Network Camera Firmware Version: V5.5.120
Release Note

Firmware Basic Information	Firmware Version:	V5.5.120 build210329

4G Solar Camera V5.5.120 Features

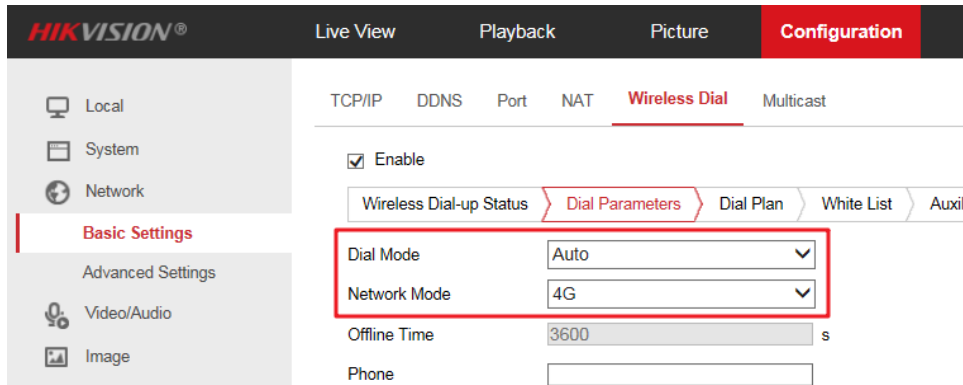
● When the DIP switch is OFF, the device does not respond to any external triggers except the DIP switch, and the upgrade will fail. It can be stored for more than 40 days with 50% power.

● All the external interfaces of the camera, such as serial port, network cable, SD card, etc., can be used normally after the DIP switch is turned on and the USB power supply is connected.
